From: [Mark Morton](#)
To: [EFSEC mi Comments](#)
Subject: Comments on HHH Council Mitigation Options
Date: Sunday, January 21, 2024 8:17:54 AM

From: [Pam Minelli](#)
To: [EFSEC mi Comments](#); info@efsec.wa.gov; [Moon, Amy \(EFSEC\)](#); [Bumpus, Sonia \(EFSEC\)](#); [Owens, Joan \(EFSEC\)](#)
Subject: Public comment on Horse Heaven Wind Project re staff recommendations
Date: Sunday, January 21, 2024 7:46:59 PM
Attachments: [TCC Wildlife Comments for 01_24_24.pdf](#)
[Final TCC New Aerial Firefighting Maps Comments 012124_3_page.pdf](#)

Overview of Comment on EFSEC Option Maps (January 19, 2024 version)

Additional Mitigation Needed Due to Aerial Firefighting

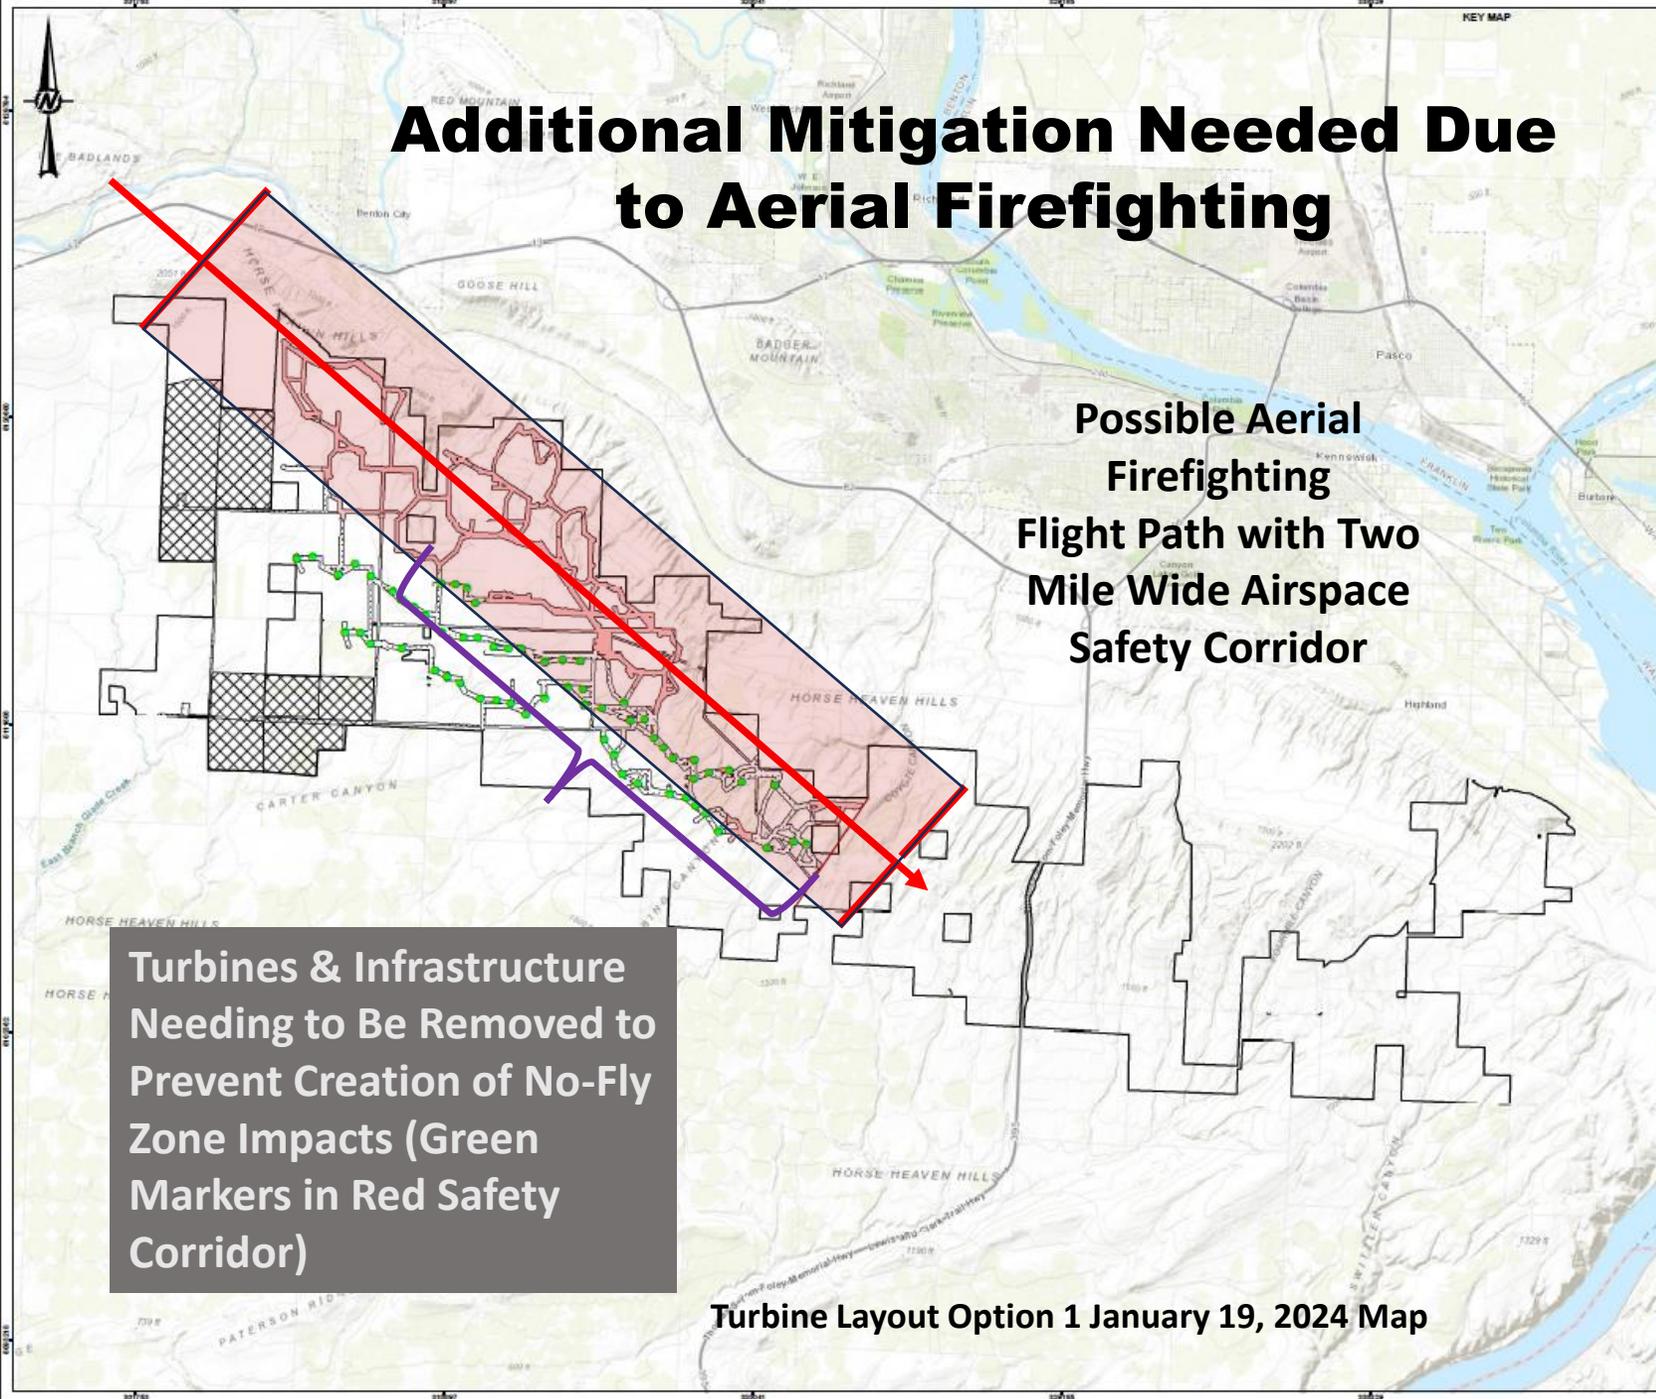
- [See attached TCC aerial firefighting maps to identify additional turbines to be removal.](#)
- Remove additional green turbines **99 to 110 and 137 to 152 of Option 1** (or taller turbines in same area in Option 2) in the center of the project to provide a safer north to south migration path for many migrating birds including the endangered Sandhill Crane and Ferruginous Hawk.

Table Identifying Additional Turbines that Need to Be Removed Due to the Visual Impacts of Turbines on KOP's in Kennewick That Were Not Identified and Included in FEIS and Data Request #7.

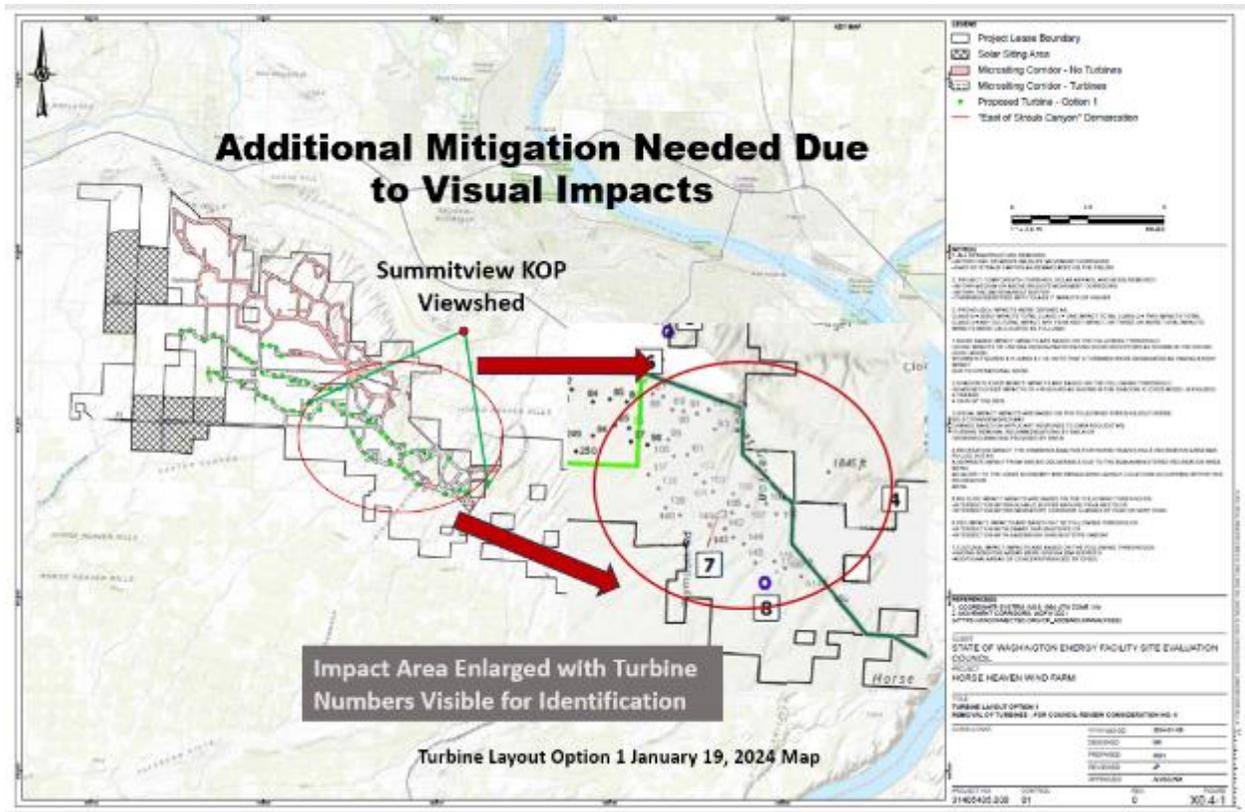
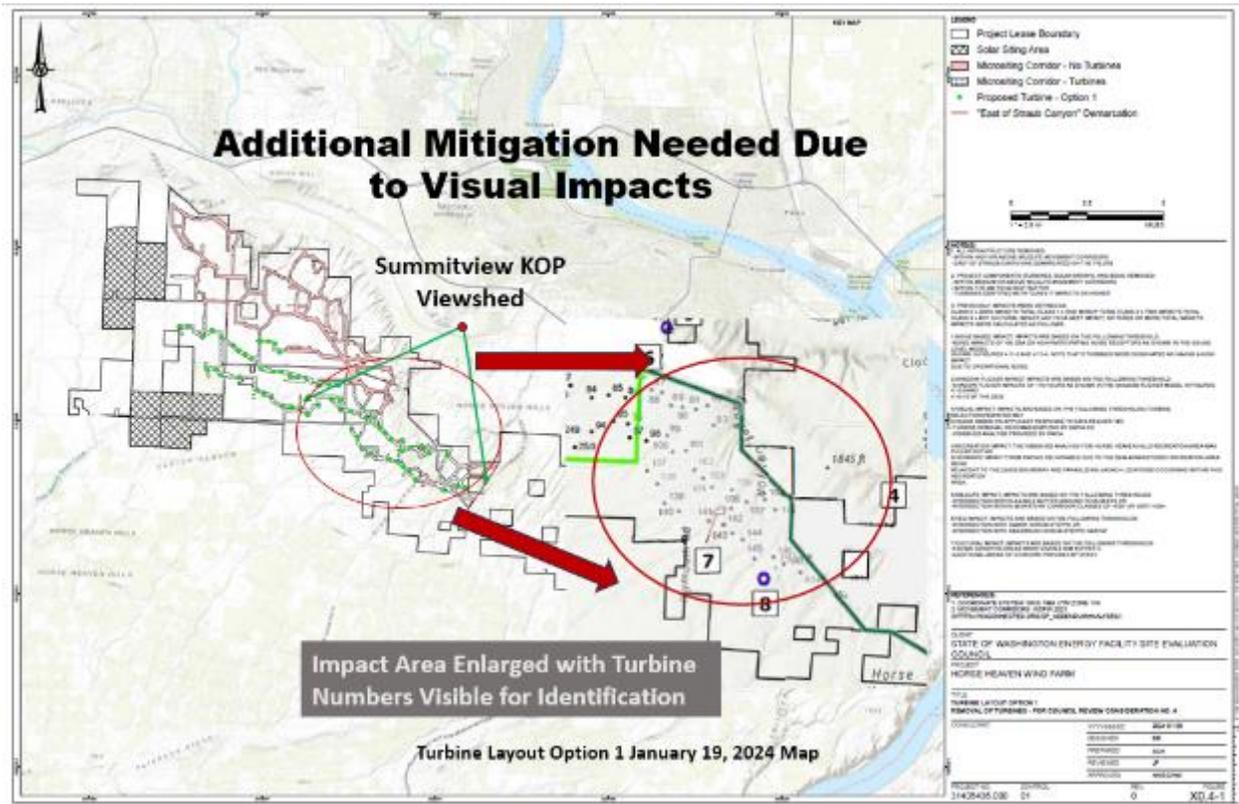
The Key Observation Point is the Summitview residences. The maps show the views depicted in the Google Earth Simulation from the Summitview Residential Community.

There is a map for Option 4 for the 496 ft high turbines and a second map for the 671 ft high turbines.

Below the maps a table is presented identifying the additional turbines that need to be removed from the project in order to protect the visual resources to the same extent as provided in the SWCA analysis done to date.

Option 1	Option 2
87	47
88	49
89	86
90	87
91	88
92	90
93	91
95	93
96	94
97	97
98	A98
99	A99
100	A100
101	A102
102	104
103	105
104	106

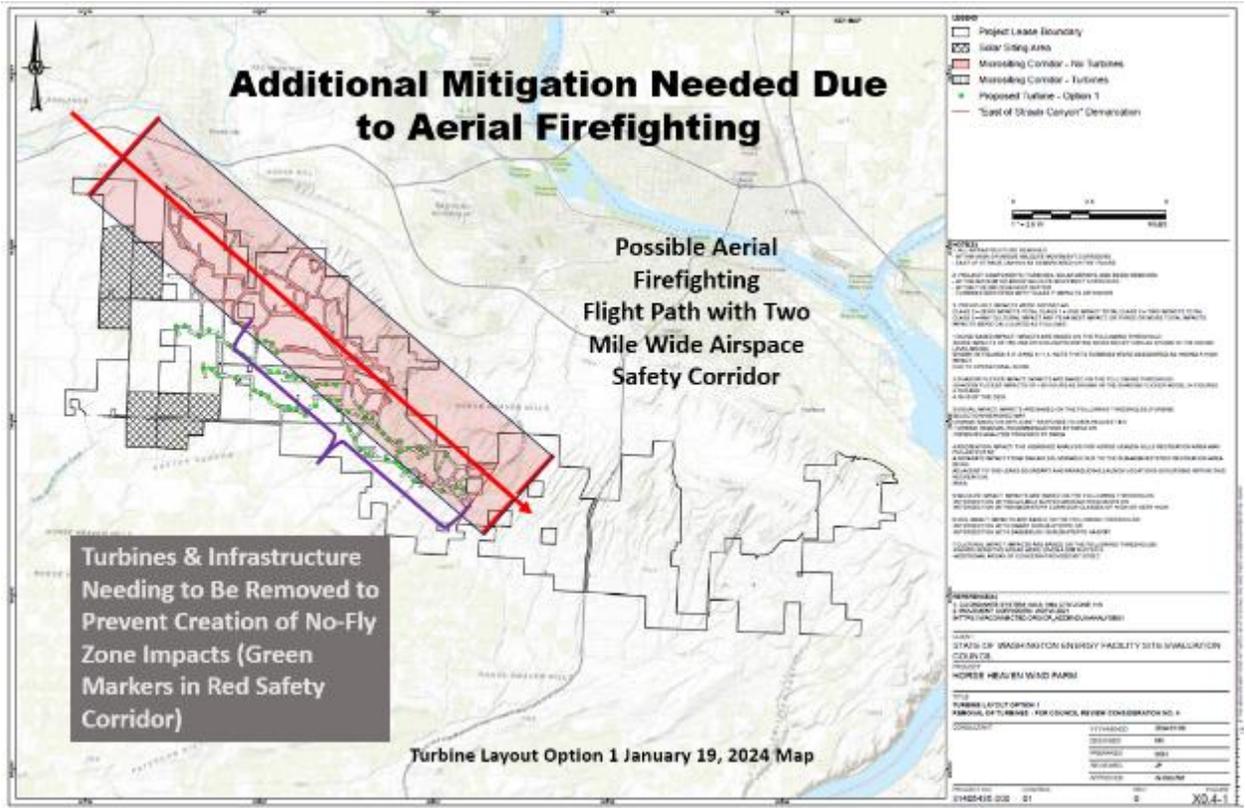
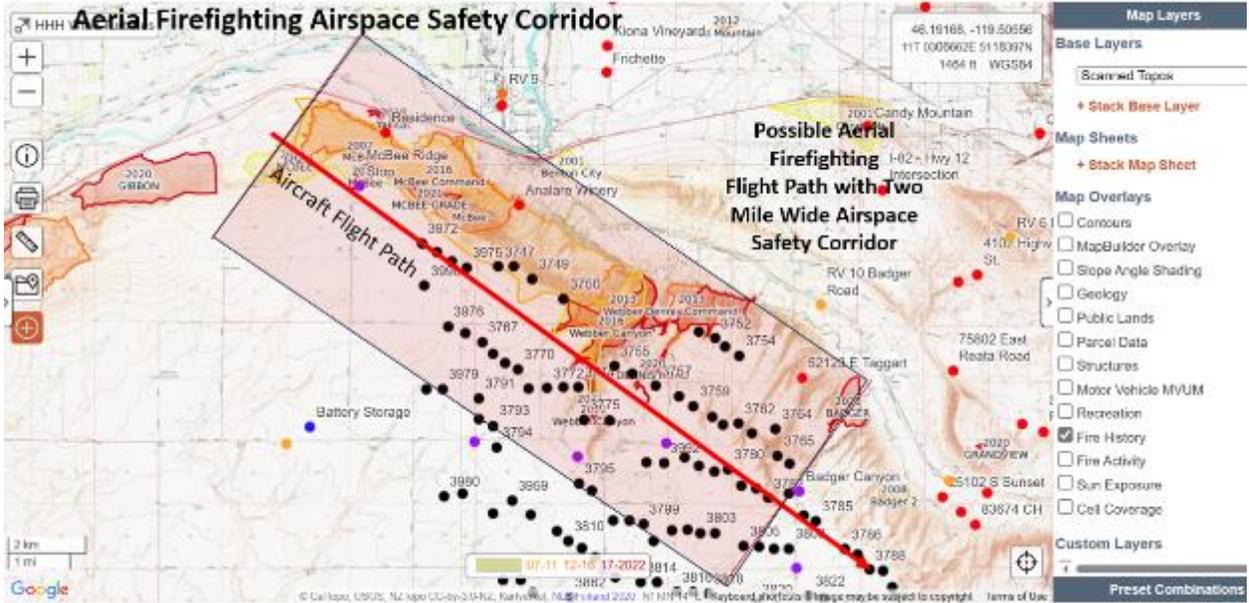
This first map shows the documented fire history of the area north and west of the project area. The map identifies a northwest to southeast flight path similar to that utilized by the DC-10 on June 13, 2023 on the Hansen Road Fire. The flight path centers on the southernmost boundary of the fire perimeter. A two-mile wide safety corridor is then drawn around the flight path, consistent with the testimony provided by aerial firefighters David Wardall and Mark Baird during the adjudication.

The next two maps on the Option 4 Maps provided to TCC on January 19, 2024 for Turbine Layouts Option 1 and 2.

In both cases there are about 20 turbines labelled in green that are within the safety corridor.

Additional Mitigation Needed Due to Aerial Firefighting

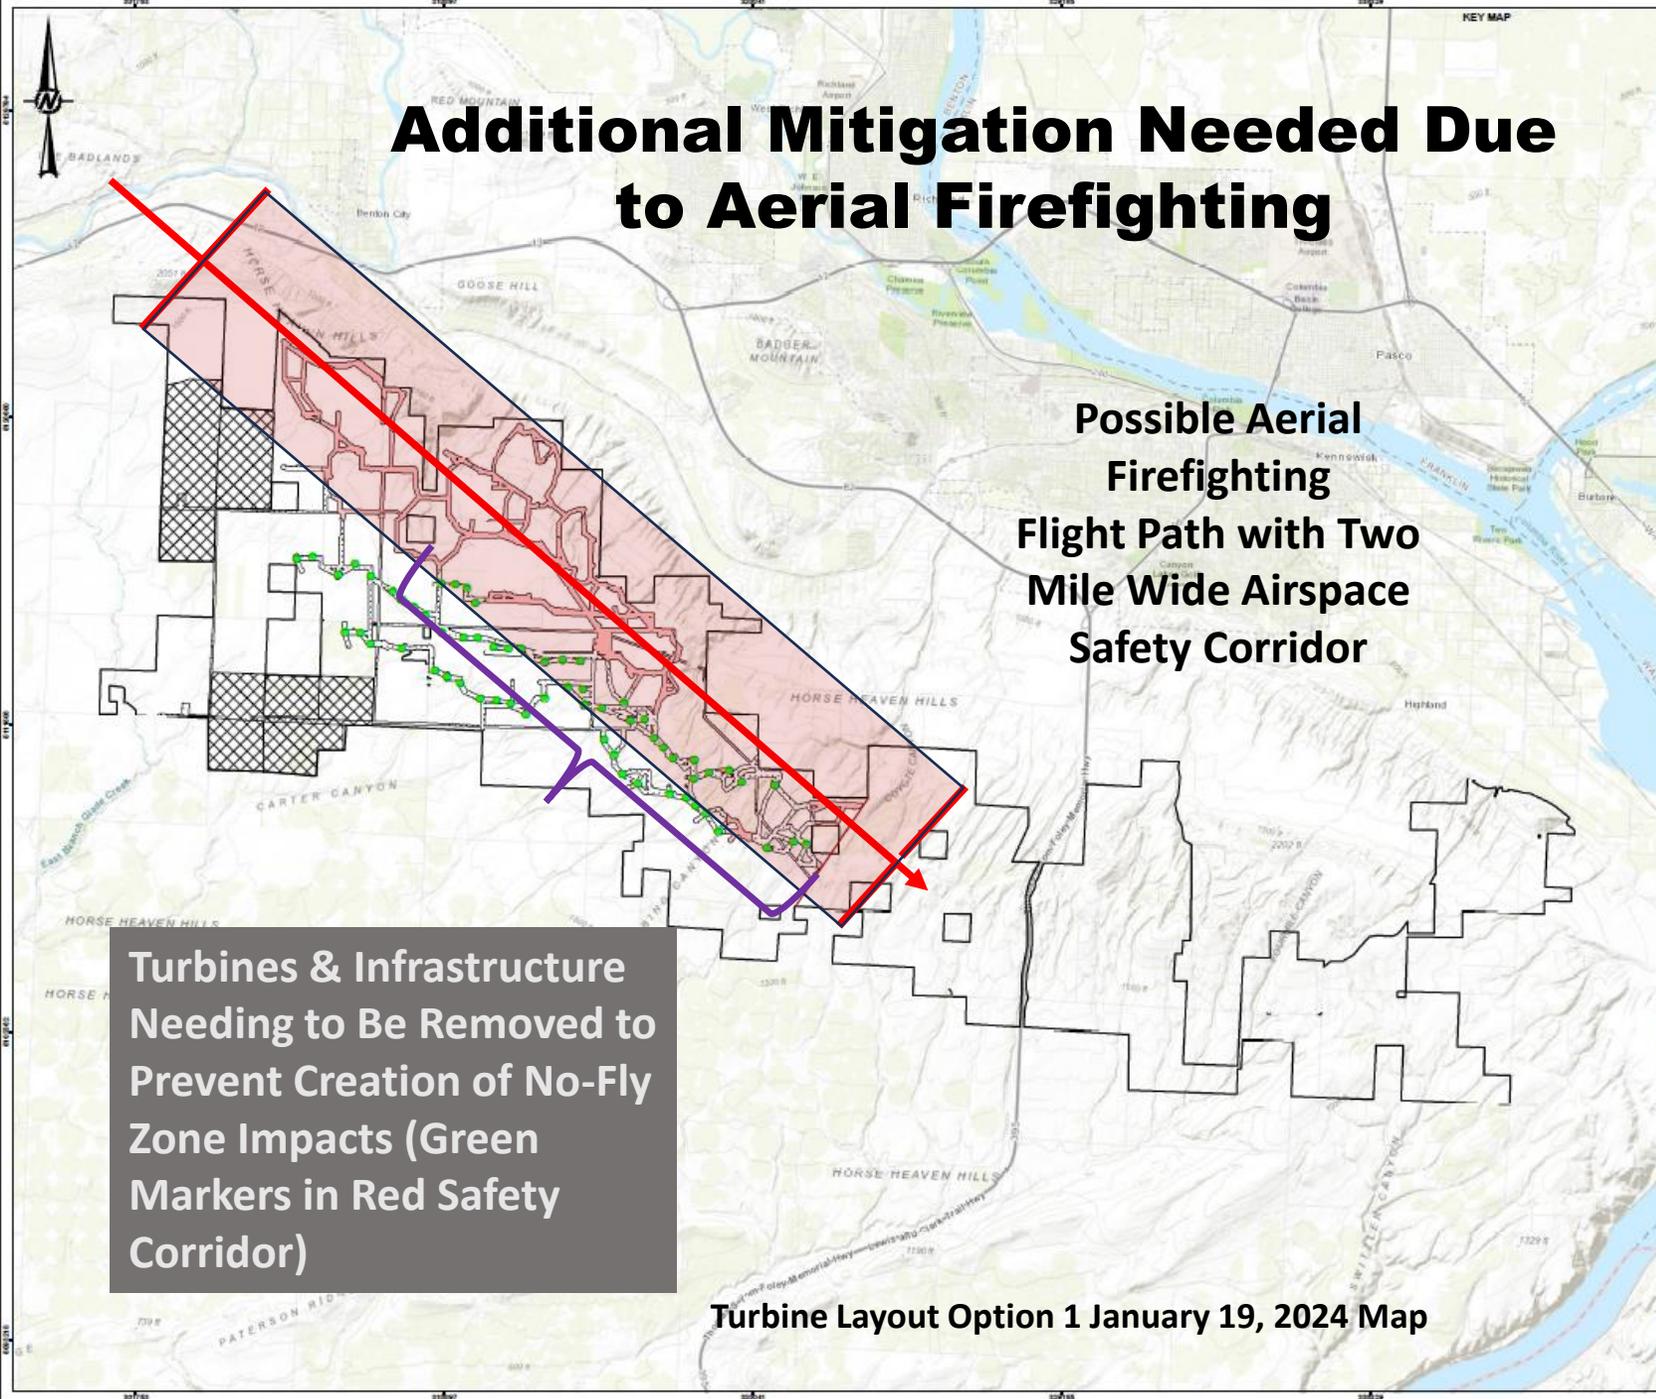
Option 4 needs to be revised to identify and remove additional turbines in order to ensure that aerial firefighting needs are addressed.
